Address: 14331 Capri Drive
Los Gatos, CA 95032

App. No.: AS – 24-043

Responses to Consulting Architect Report

Letter of Justification (Shed Roof)

Shed Roof @ Master Bedroom

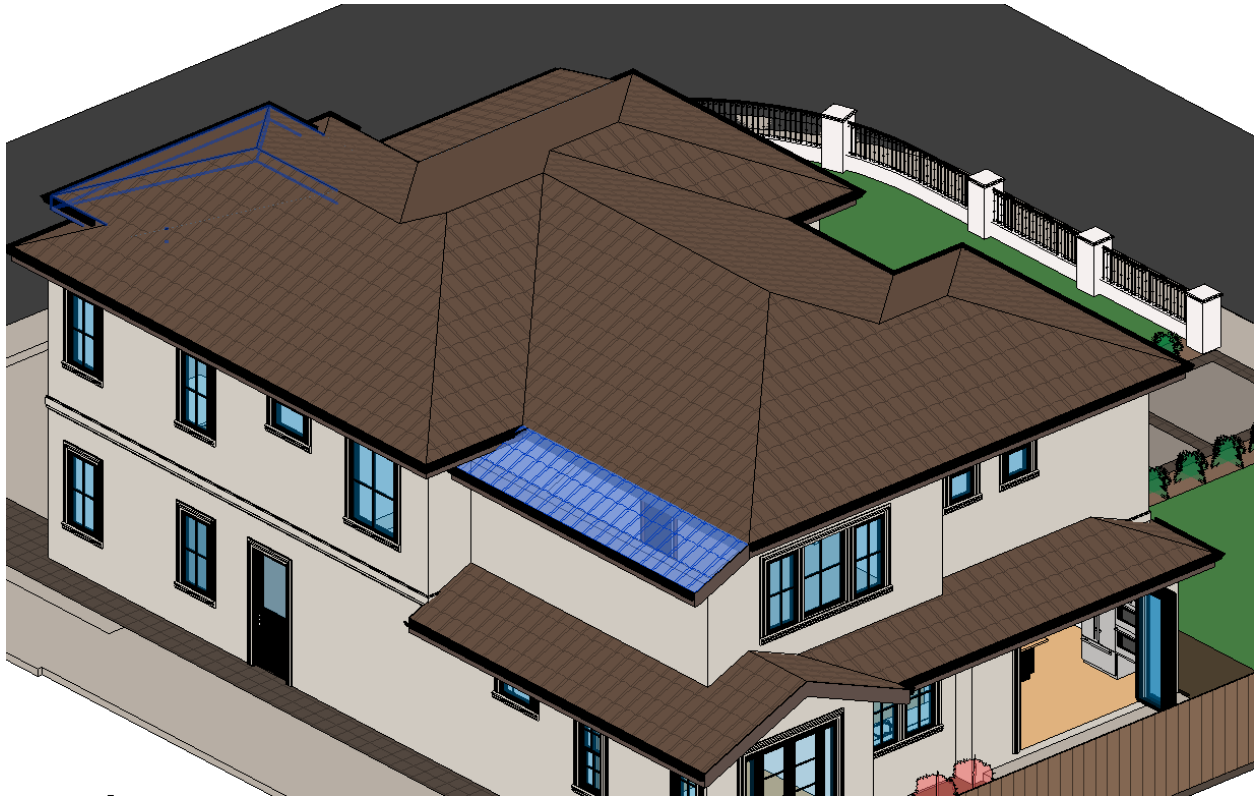
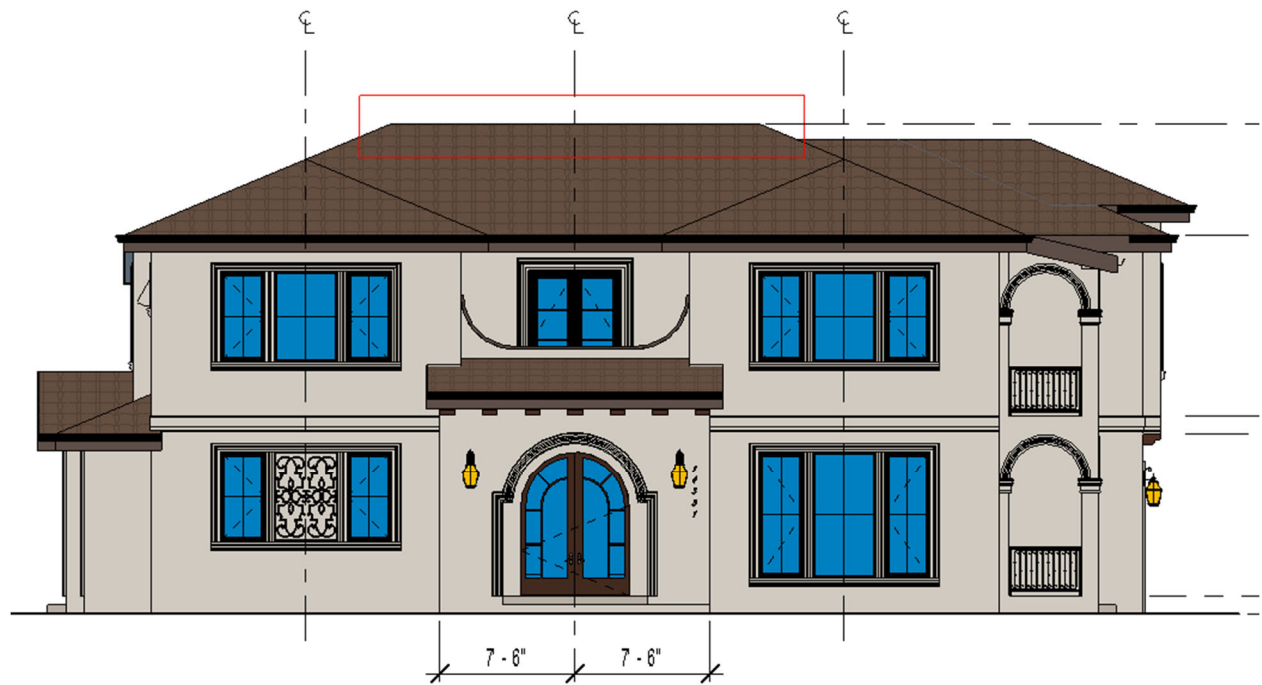
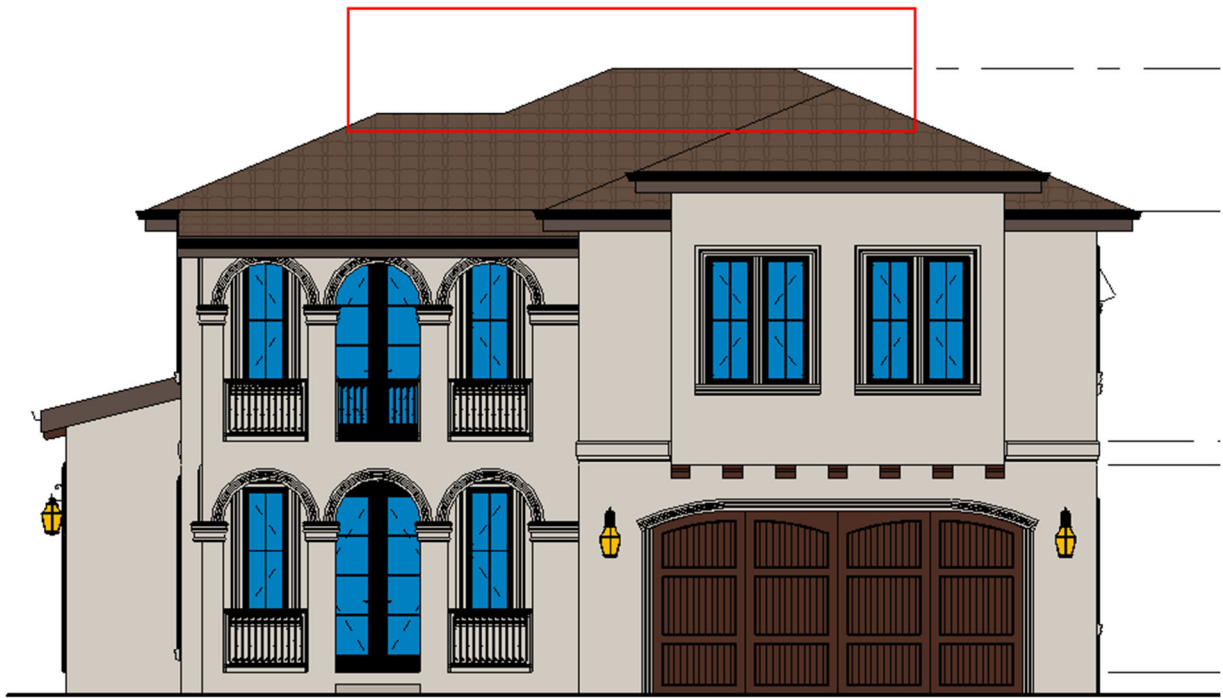
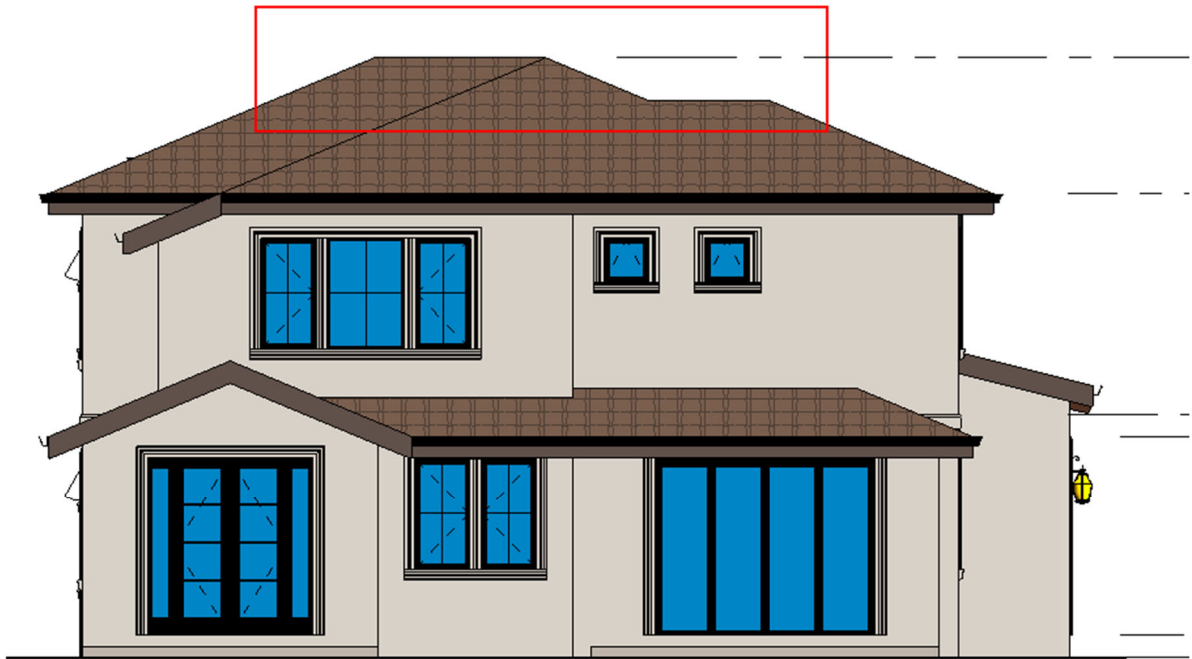
7. Substantially recess the garage door.
Per recommendation, garage door is recessed in by 12 inches.
8. Change the extended roof overhang at the Master Bedroom on the rear elevation to a hip roof.

Conclusion: By comparing the elevations, the peak of the roof has increased by 11 inches without adding the shed roof at the master bedroom. In addition, North and South elevations indicate the excessively sharp peak at the center of the roof which makes the whole roof shape overly convoluted and awkward. By adding the shed roof at the master bedroom side, the peak of the roof softens as a result of no awkward shape peaks. In addition, this is compatible with Los Gatos Residential Guidelines – Building Design Section 3.5 as follows:

This cannot be done as it will result a cricket in between two hips. In addition, the roof was carefully designed in a way to reduce the amount of “pointy” peak while keeping the simplicity of the ridge lines. **Please see separate attachment “14331 Capri Dr – Letter of Justification For Shed Roof” for further details and justification.**
